# Access Compliance Report

## Public Rights-of-Way

Intersection ID: 2827	Main Street: DERVISH_LN	Cross Street: SWALLOW_TAIL_LN	Location: E
ADA ID: 3622EEA269D7	Ramp Type: PerpDiag	Initial Pass/Fail: Fail	Overall Compliance: No
Severity Score: 33.75			
Codes/Mitigation Info/Possible Solution		Field Measurements/Component Compliance

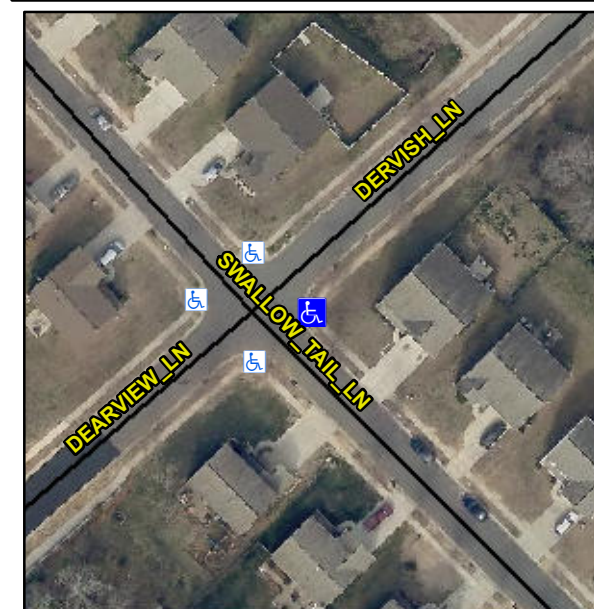
**Not Found, R304.5.1, R304.5.3**

Compliance	Description	Data	Compliance	Description	Data
N/A	Ramp Length (in)	48.0	Yes	Ramp Slope (%)	5.3
No	Ramp Width (in)	40.0	No	Ramp XSlope (%)	9.0
N/A	Flare Type LT	N/A	N/A	Flare Type RT	N/A
N/A	Flare Slope LT (%)	N/A	N/A	Flare Slope RT (%)	N/A
N/A	Flare Traversable LT?	N/A	N/A	Flare Traversable RT?	N/A
N/A	Landing Length (in)	N/A	N/A	DWS Provided?	N/A
N/A	Landing Width (in)	N/A	N/A	DWS Contrast?	N/A
N/A	Landing Slope (%)	N/A	N/A	DWS Length (in)	N/A
N/A	Landing X Slope (%)	N/A	N/A	DWS Full Width?	N/A
N/A	Landing Curb? (Y/N)	N/A	N/A	DWS Offset (in)	N/A
N/A	Shared Landing?	N/A			
N/A	Gutter Ponding?	N/A	N/A	Gutter Slope (%)	N/A
N/A	Gutter Lip Ht (in)	2.0	N/A	Gutter X Slope (%)	N/A
N/A	Painted X Walk1?	No	N/A	Painted X Walk2?	No
	X Walk 1 Direction	To NW		X Walk 2 Direction	To SW
N/A	X Walk 1 Width (in)	N/A	N/A	X Walk 2 Width (in)	N/A
	X Walk 1 Slope (%)	3.2		X Walk 2 Slope (%)	7.8
	X Walk 1 X Slope (%)	4.5		X Walk 2 X Slope (%)	2.0

**Remove & Replace Curb Ramp With Two New Directional Ramps or Equivalent.**
